Comments and Responses to Comments on the Draft EIS/EIS/EIR

**Responses to Comments on the Draft
EIS/EIS/EIR**

P. COMMENTS AND RESPONSES TO COMMENTS ON THE DRAFT EIS/EIS/EIR

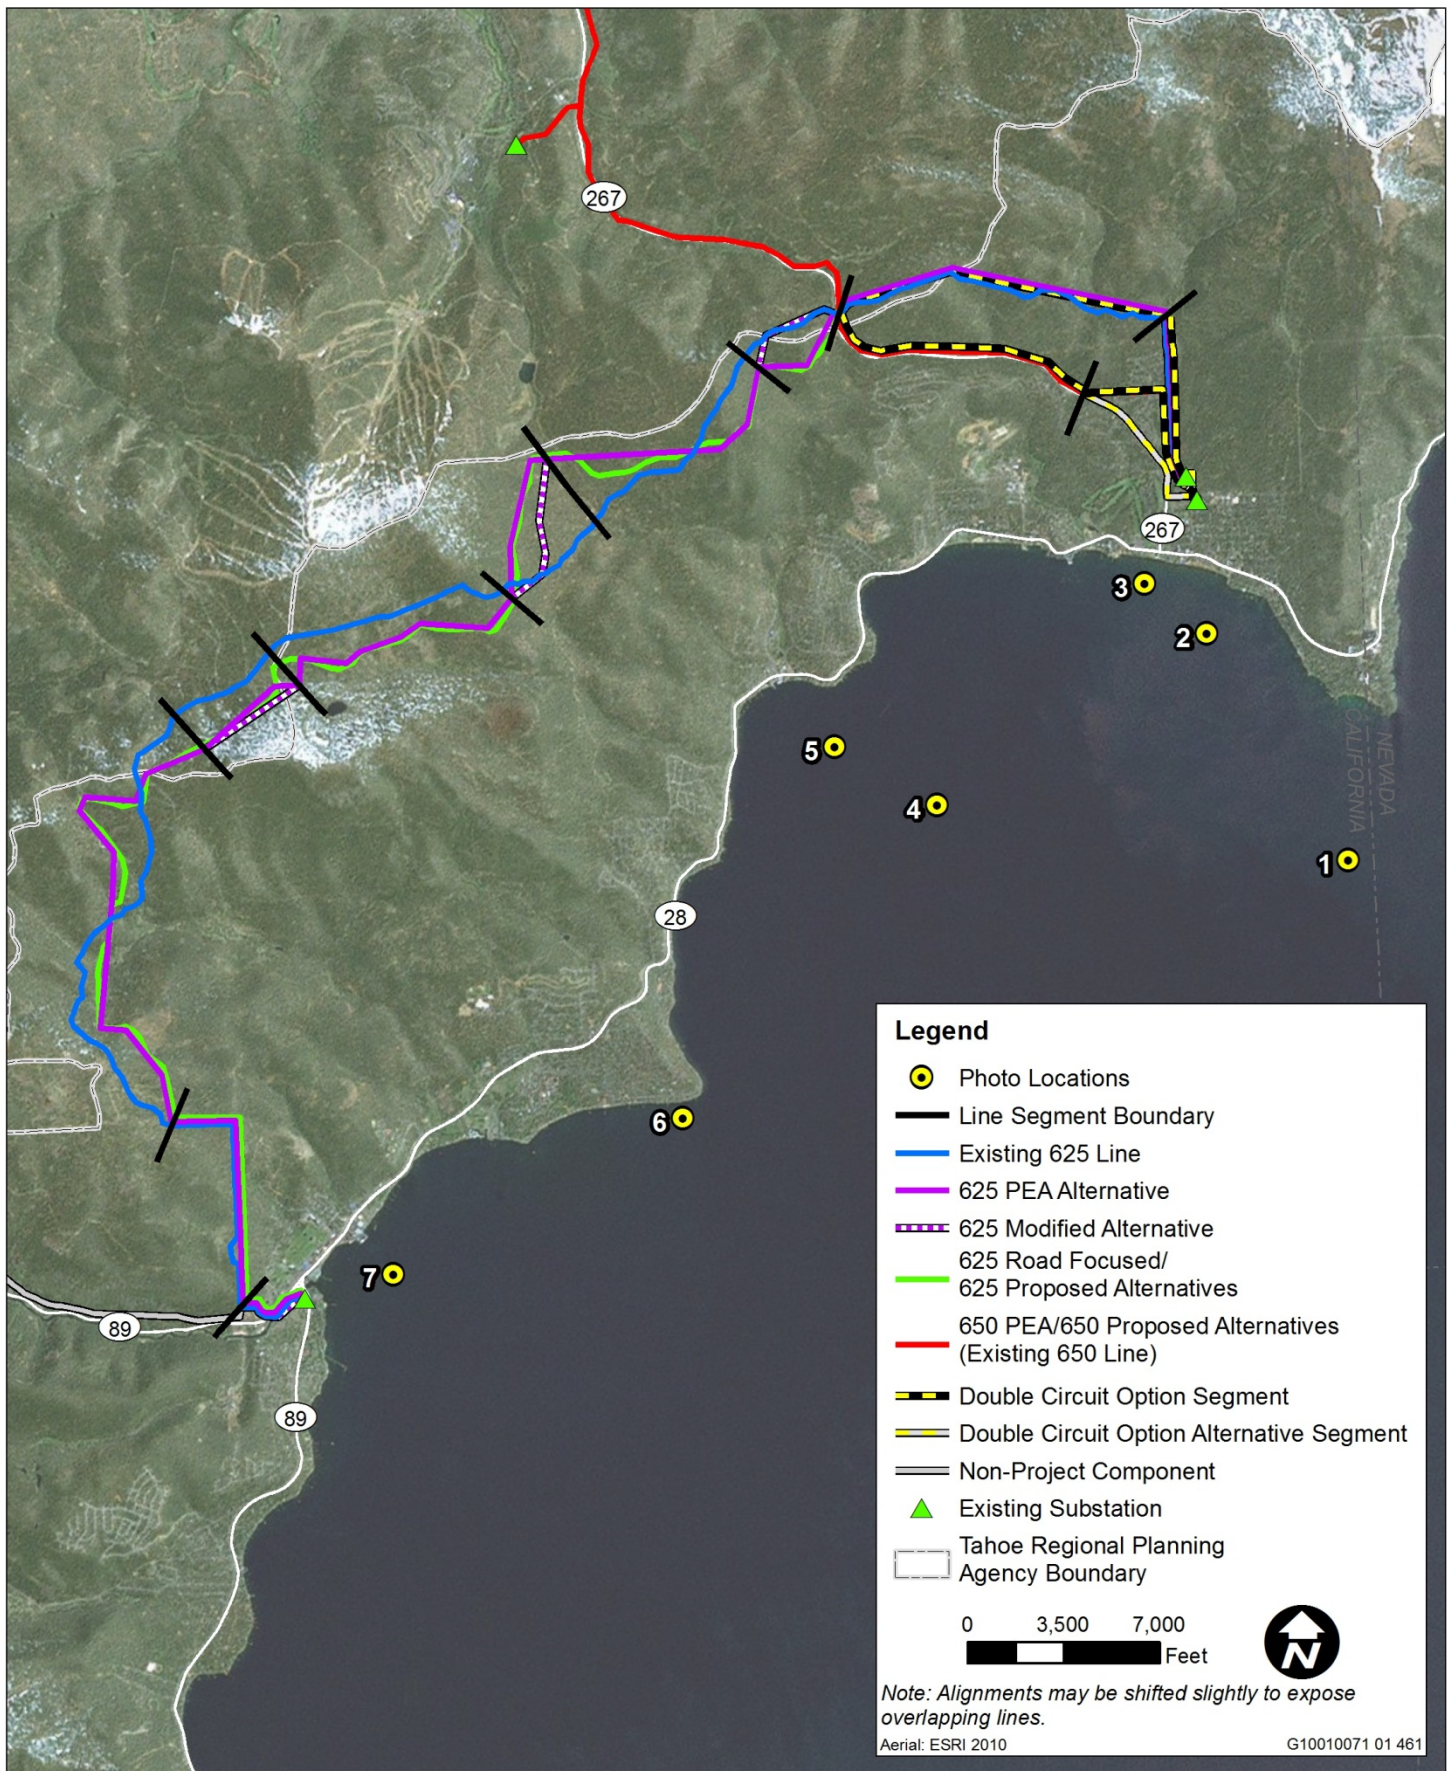
- 24-2 The comment states that, based on Exhibit 4.4-3 in the Draft EIS/EIS/EIR, scenic impacts from the point of view of the lake need to be analyzed and that views from ridges, hills, and lookouts, such as the ridge near the California-Nevada border and the Stateline scenic lookout area, should also be evaluated. The comment suggests that photo simulations from these viewpoints should be included in the Final EIS/EIS/EIR.

To further test and verify project visibility from the Lake Tahoe surface, on March 13, 2014 a boat was chartered (the Hopper V) to take photos of the project area from various locations on the lake. Staff representing the USFS, TRPA, and the lead agencies’ consultant team were present. A Trimble GeoXH GPS unit was used to record the boat’s location at each point where photos were taken. Exhibit 24-2A shows the seven Lake Tahoe surface photo locations as well as the locations of the existing 625 and 650 Lines and the proposed routes under each action alternative. Photo locations were selected to provide potential views of the lines where they were closest to the lake and to test the visibility of the 625 Line between Tahoe City and Kings Beach. Photo Location #6 was added while in the field based on the visibility of a portion of the existing 625 Line, as described below.

Exhibit 24-2B shows a photo from Photo Location #1, approximately 2.5 miles southeast of the intersection of SRs 267 and 28. The photo is taken towards Kings Beach and the SR 267 ROW can be seen running east to west towards Brockway Summit. However, the existing 650 Line along the SR 267 ROW is not discernable, and no other elements of the existing 625 and 650 Lines can be seen. This photo supports the lack of visibility of project features from background (i.e., greater than 4 miles) distances that would be typical of most views from ridges, hills, and lookouts, and the importance of topographic and vegetative screening.

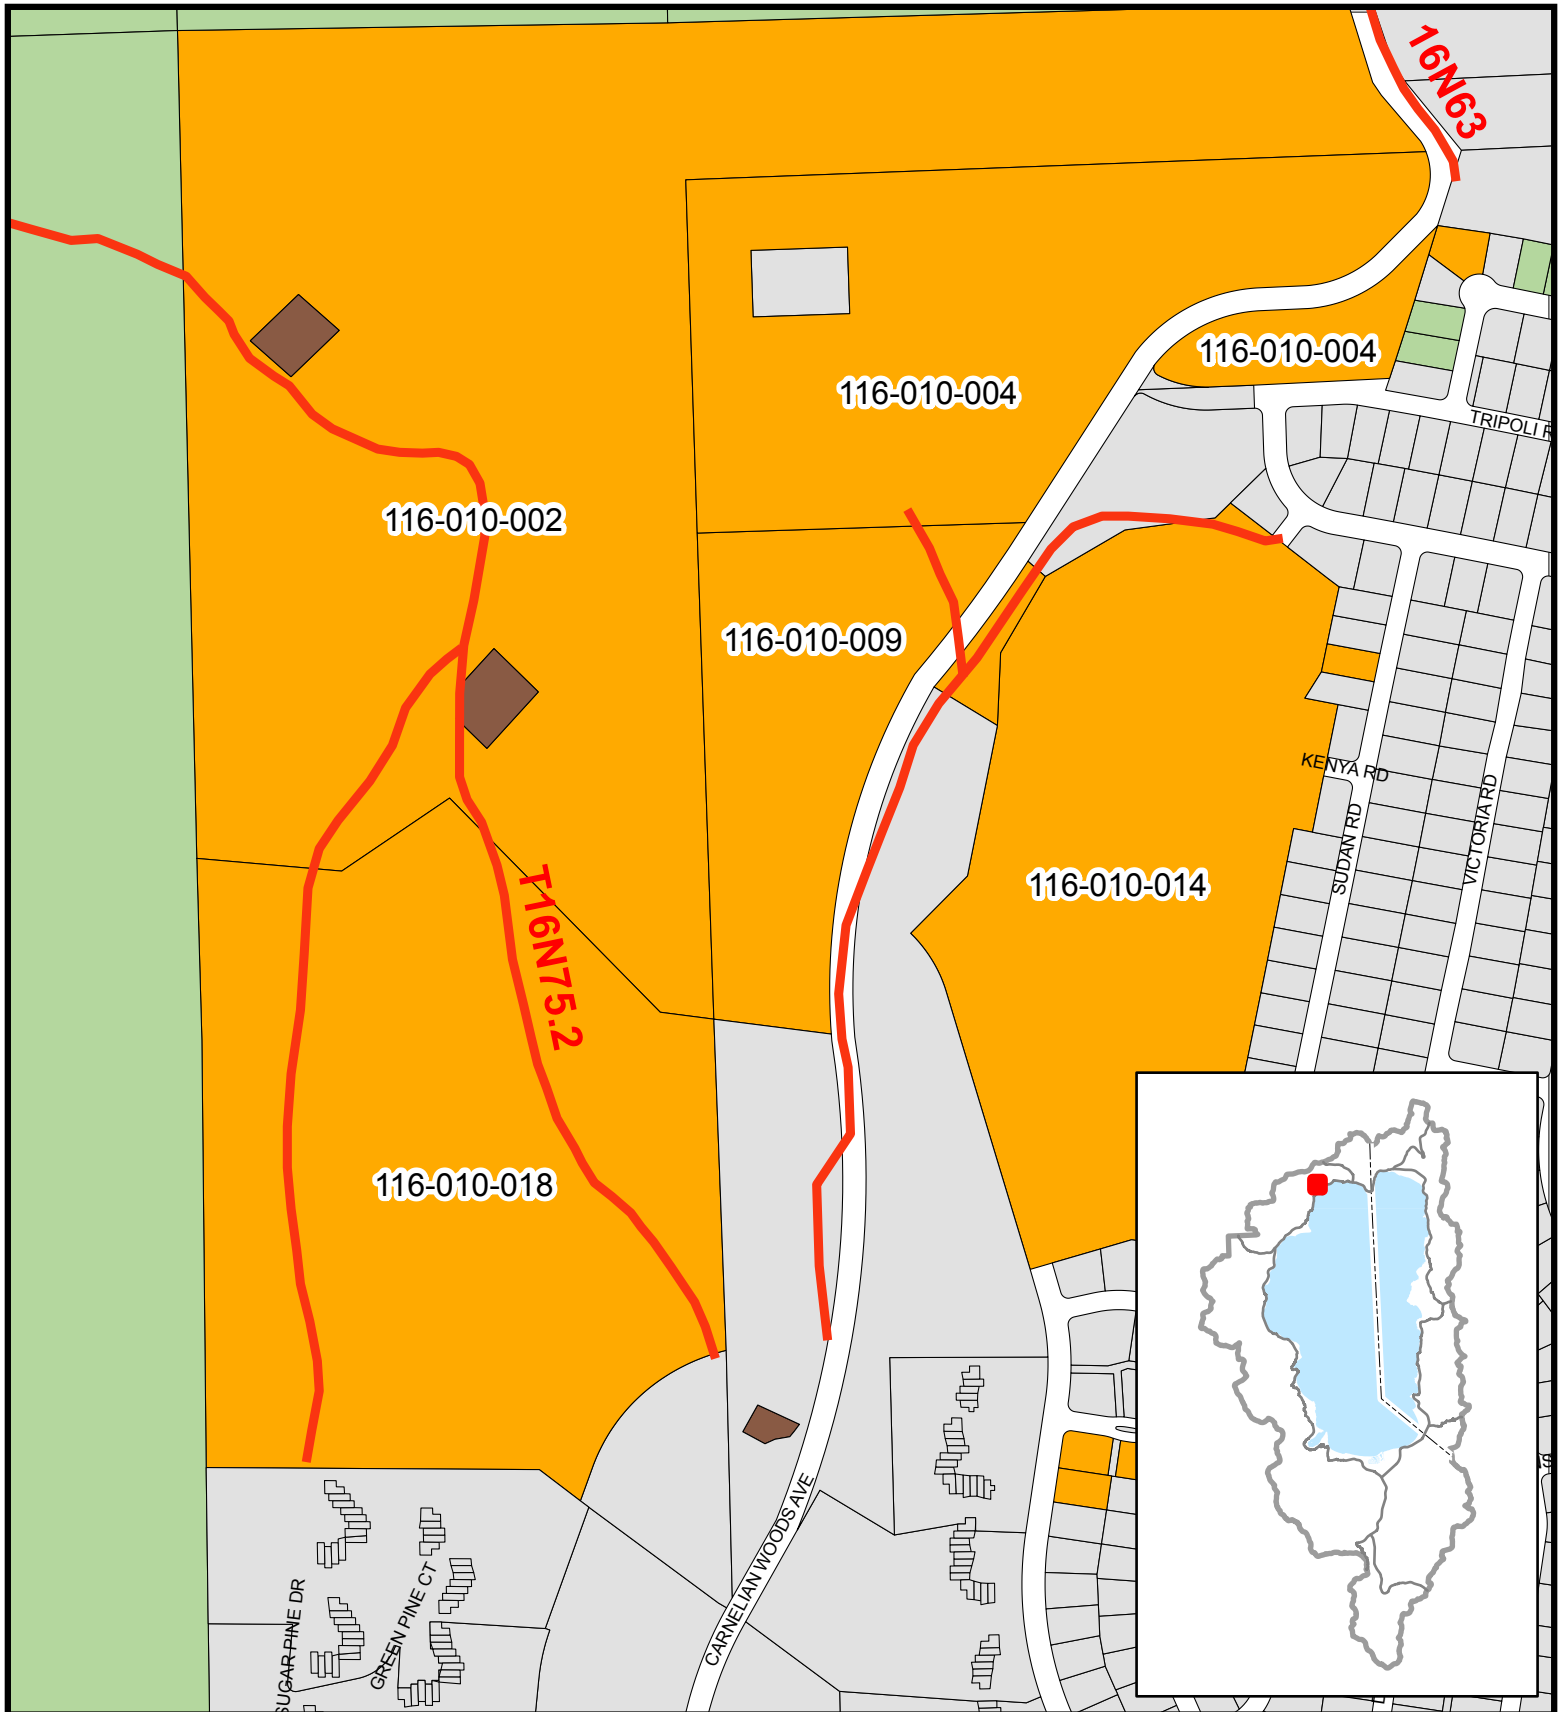
Also, as you will see on the attached 95% plans, sheet C2, the NTPUD is proposing to construct some improvements and reroute the upper section of T16N75.2 on Conservancy lands because it has direct hydrologic connectivity to Carnelian Creek. The Biological and Cultural surveys have been completed and the NTPUD Board of Directors adopted the MND for our project on December 10, 2013. The Conservancy will be granting additional easements to the NTPUD for BMP maintenance as early as their March 2014 CTC Board meeting.

This email serves as formal notification that the North Tahoe Public Utility District objects to the decommissioning of road T16N75.2 in the areas that are on Conservancy lands and NTPUD's easements for public health and safety as this is the only water supply for our customers in our Carnelian Bay system.
